**Report to
Development Permit Panel**

File: DP 06-347920

Re: **Application by Arcadian Architecture Inc. for a Development Permit at 9451
Blundell Road**

**Excerpt from the Minutes from
The Design Panel Meeting**

1 FRONT ELEVATION/BLUNDELL
SCALE 1/8"=1'-0"

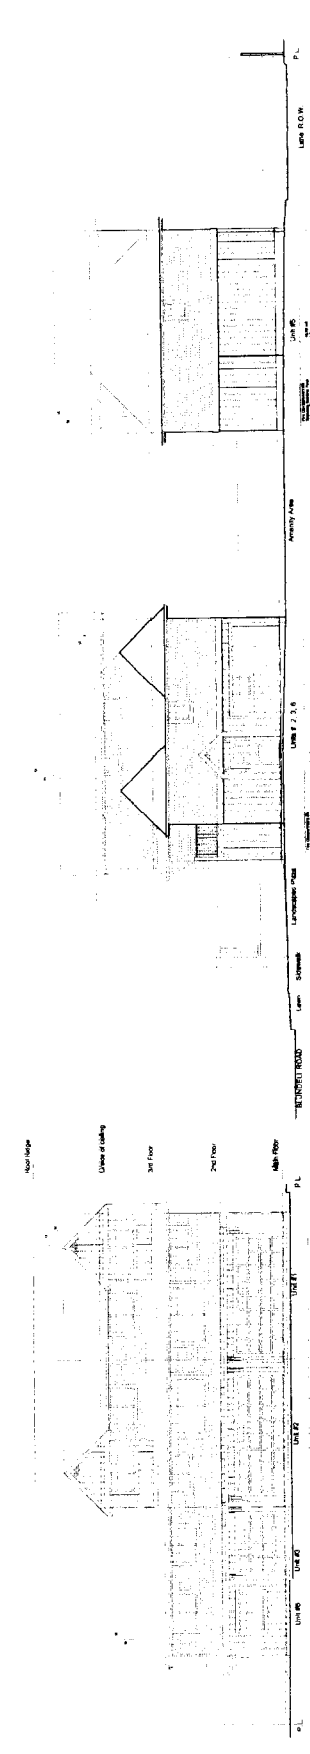
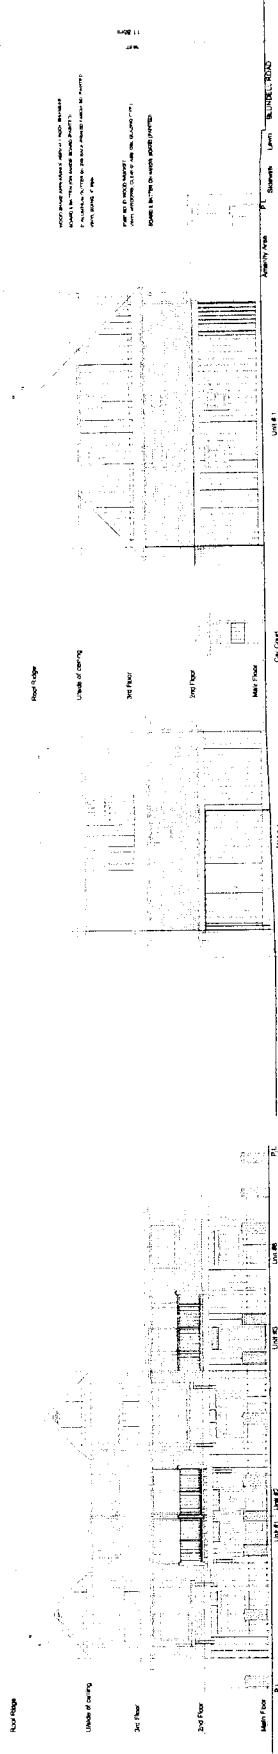
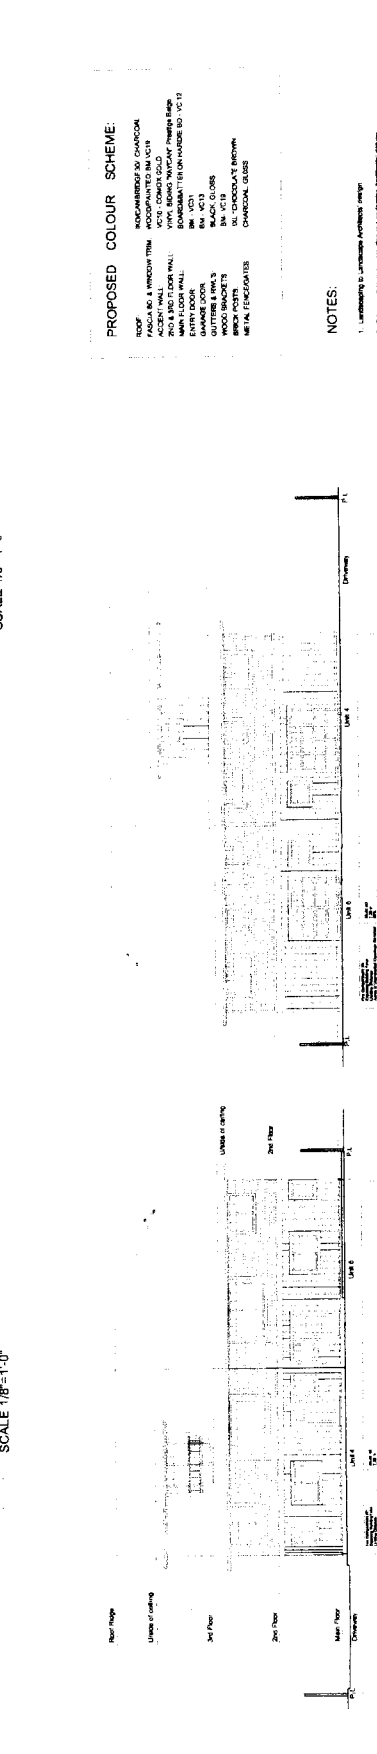
- public realm on along Blundell Road should be as friendly as possible;
- if squaring the corner is not an option, as a compromise, consider exploring base level treatment in terms of how the doorways can be more generous and; **SW corner of unit #1**

- **squared-off; Doorways accentuated by projecting balconies and adding solid wood brackets (see revised drawings).**
- look at massing vertically to create more of an edge; presently it feels like a basement level unit; **Bay windows of 2nd and 3rd floor lined-up; solid wood brackets added as support, bay windows possible for main floor dens, Unit #1 and #2- if allowed.**

- further develop the elevation to the entry porch of unit #6, it presently looks unresolved along the side elevation; **Wider trim and solid wood brackets accented.**

- reconsider the dark colour of the upper storey to avoid a feeling of the roof coming down onto the building; **Colour revised; to match hardie siding of 2nd floor.**

ROOF PLAN
 SCALE 1/8"=1'-0"

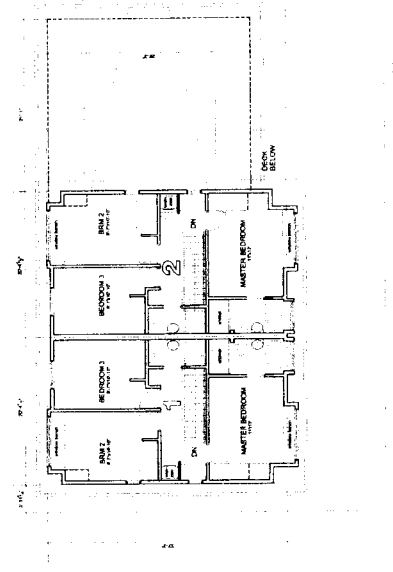
- appreciated the simplicity of the roof on the smaller building;
- the roof plan for the larger building is more complex than it needs to be; **Roof simplified thanks to squaring-off the SW corner.**
